ADDENDUM TO THE 2012 FINAL REPORT OF THE ENVIRONMENTAL IMPACT ASSESSMENT: Coral Springs Residential Development

April 3, 2013

Prepared for:
National Environment and Planning Agency
10 Caledonia Avenue
Kingston 5

Prepared by:
Environmental Solutions Ltd.
89 Hope Road
Kingston 6

Figure 2.2a: Contours after re-grading below the 15 m line (FCS Consultants Ltd, 2013)

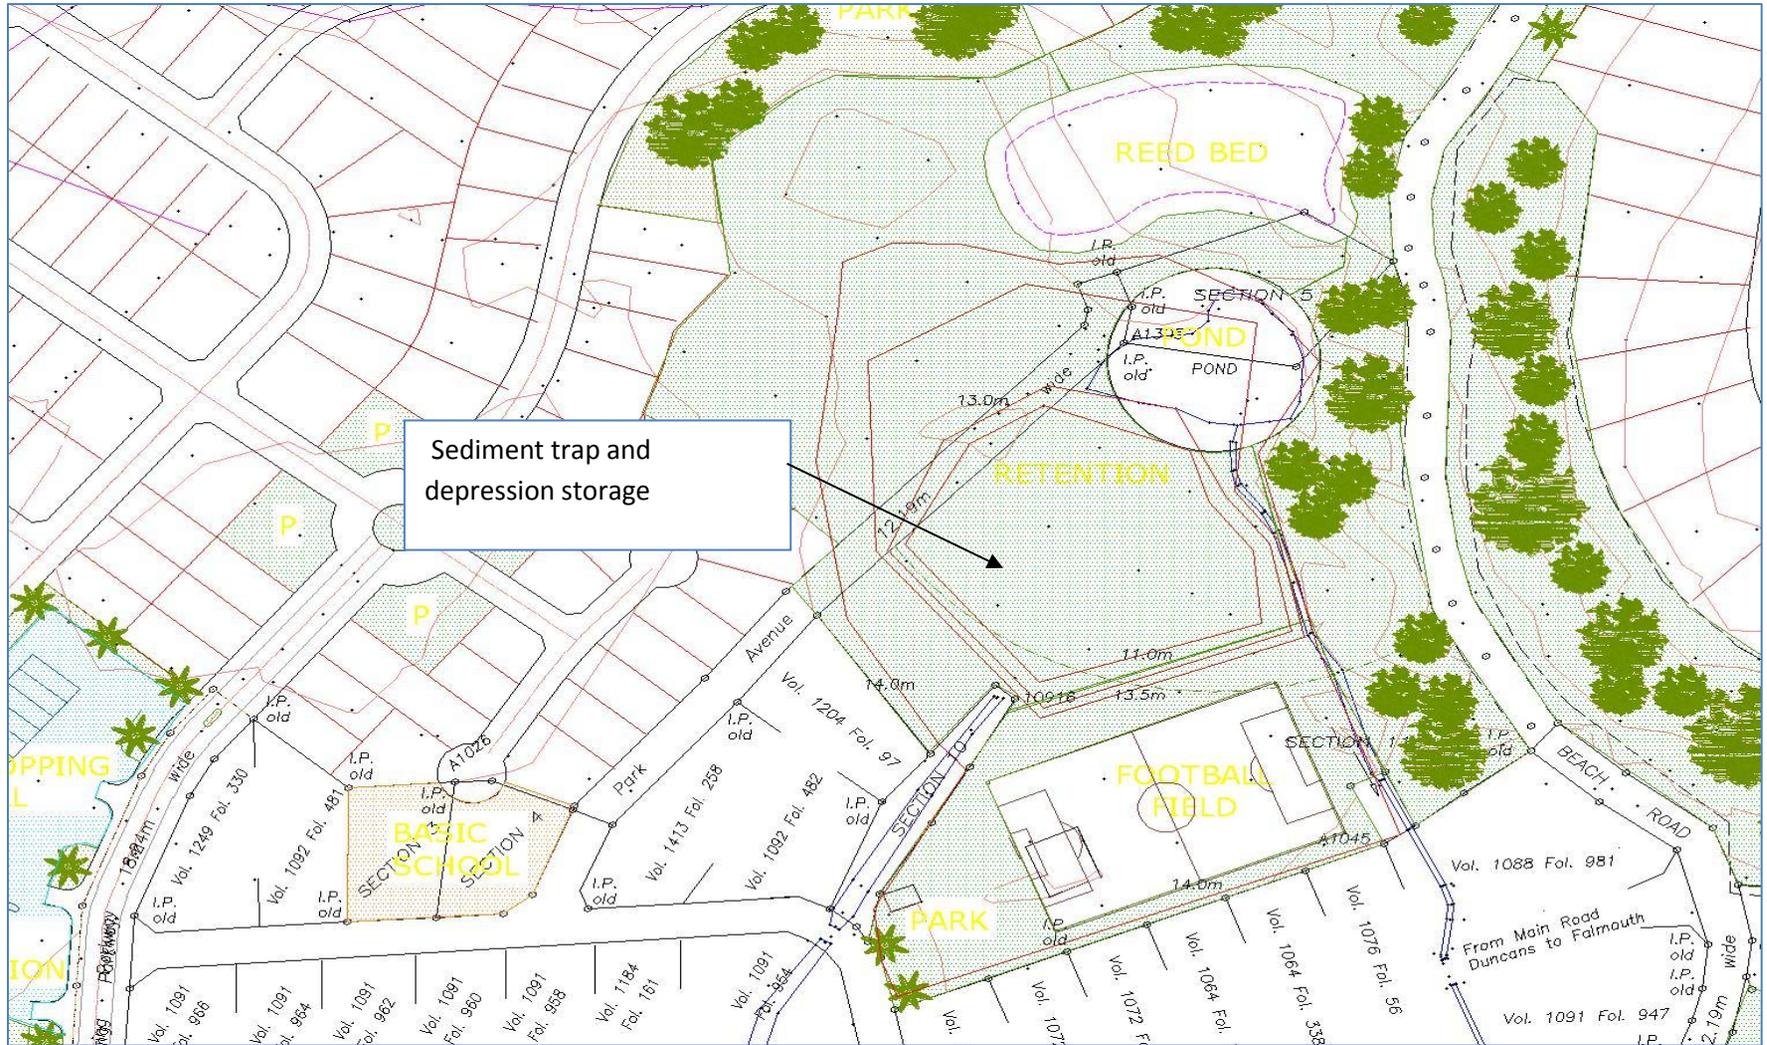
<ul style="list-style-type: none"> The proposed modification to mitigate flooding is to excavate hard brown clay above the standing water elevation and fill it with compacted gravel or crushed limestone then landscape and use as a park. This is projected to reduce flood levels by up to 0.78m. The EIA study however does not clearly indicate whether or not this would be sufficient to fully counteract the flooding problem. More clarification is therefore needed about this and the entire drainage and sewerage system to ensure that the existing residents will not be at a disadvantage as a consequence of the proposed drainage modifications.
24	ESL Response	See Drainage Reports of 2012 and 2013 .
25	NEPA Comments	<ul style="list-style-type: none"> There is no mention of the effect of large scale vegetation clearance and the expected increase in runoff that this will result in particularly as it concerns the issue of flooding. The existing residents currently suffer from flooding after significant storm events and the increased run-off may have the possibility of exacerbating this problem. The report on page 56, under title 'Flooding', indicates that areas may remain flooded for weeks to months and that flood waters can reach onto the verandahs of existing residents adjacent to the sinkhole and remain for up to two (2) days. These are serious concerns and the EIA and related studies must demonstrate that the modifications to the site and the introduction of a development of this magnitude will not negatively impact the existing residents or exacerbate the prevailing conditions.

- The proposed modification to mitigate flooding is to excavate hard brown clay above the standing water elevation and fill it with compacted gravel or crushed limestone then landscape and use as a park. This is projected to reduce flood levels by up to 0.78m. The EIA study however does not clearly indicate whether or not this would be sufficient to fully counteract the flooding problem. More clarification is therefore needed about this and the entire drainage and sewerage system to ensure that the existing residents will not be at a disadvantage as a consequence of the proposed drainage modifications.

Additional geotechnical sampling performed in the depression in February 2013 shows ~6 m of clay in the pond area above the free draining material of the sinkhole. It is now proposed that modifications be done in the area between the pond, the drain and the playfield to create detention storage, and a sediment trap (Figure 2.2a) to create an area of increased percolation around the pond/depression.

The re-grading will be done by excavating between the 13.0 m contour and the 14.0 contour to remove the hard brown clay. The area will then be filled with compacted gravel and crushed limestone to 11.0 m to create additional storage. A sediment trap and recharge area will essentially be created (Figure 2.2a). The area below the 15 m line, south of the sinkhole, will also be re-graded to facilitate the play field; though less extensively than the sediment trap area.

Figure 2.2b: Demarcation of post-development 100 year flood elevation with no mitigation (FCS Consultants Ltd, 2013)

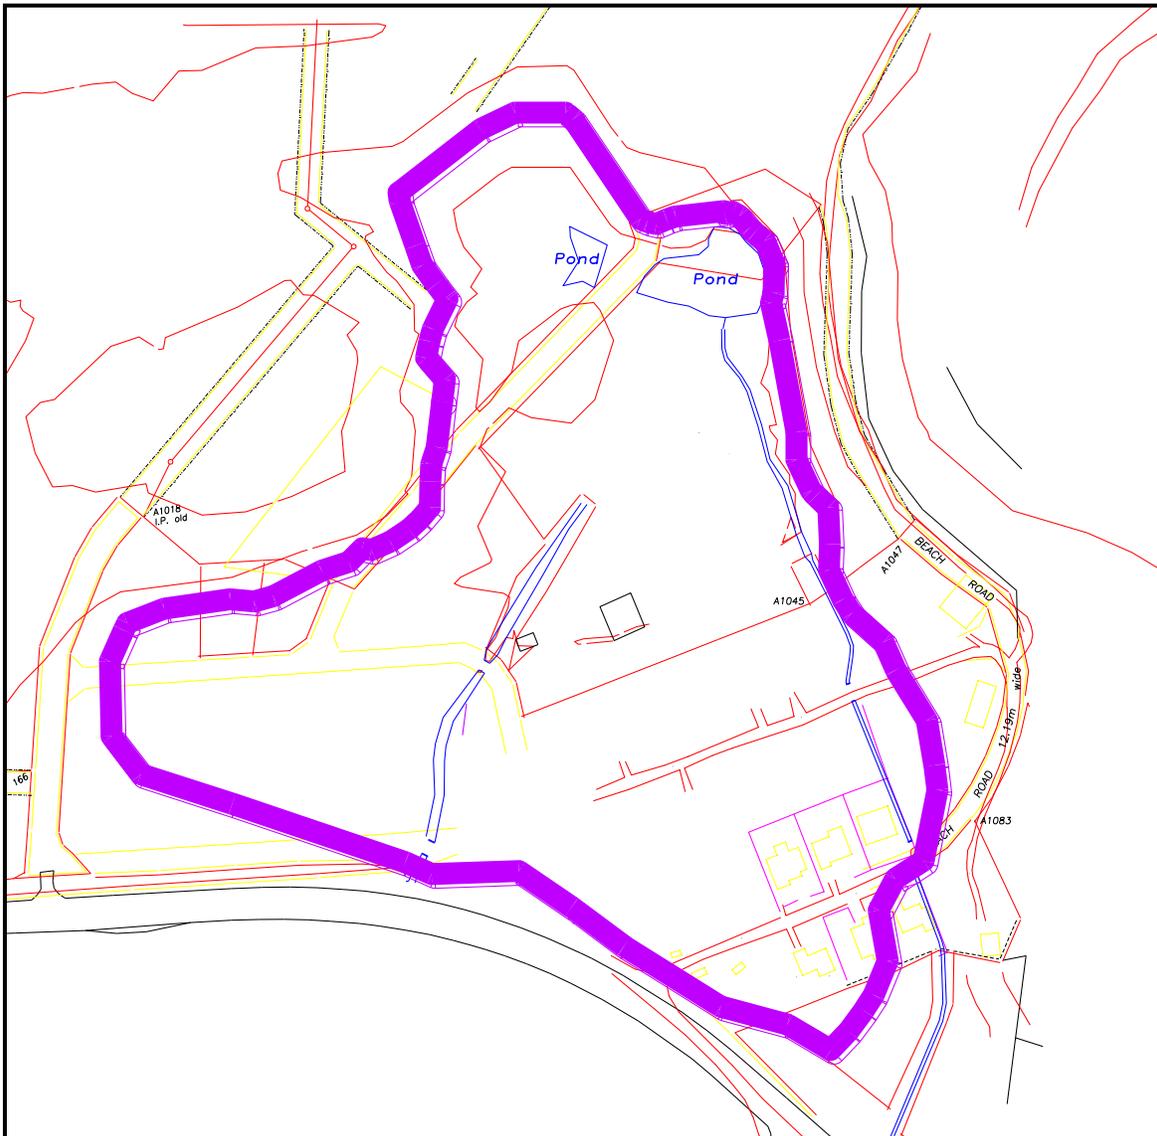
- There is no mention of the effect of large scale vegetation clearance and the expected increase in runoff that this will result in particularly as it concerns the issue of flooding. The existing residents currently suffer from flooding after significant storm events and the increased run-off may have the possibility of exacerbating this problem. The report on page 56, under title 'Flooding', indicates that areas may remain flooded for weeks to months and that flood waters can reach onto the verandahs of existing residents adjacent to the sinkhole and remain for up to two (2) days. These are serious concerns and the EIA and related studies must demonstrate that the modifications to the site and the introduction of a development of this magnitude will not negatively impact the existing residents or exacerbate the prevailing conditions.

Re-grading and removal of the clay layer in the park location will reduce flood levels in the 100yr storm by approximately from 18.08 m to 15.48 m (Table 2.2). This is expected to alleviate the threat to existing properties as the lowest floor level is 15.83 m. Figure 2.2b and c below show the difference in the 100 year flood plain with and without the proposed drainage mitigation measure of creating a sediment trap and storage area around the depression.

Figure 2.2c: Demarcation of post-development 100 year flood elevation with mitigation (re-grading) (FCS Consultants Ltd, 2013)
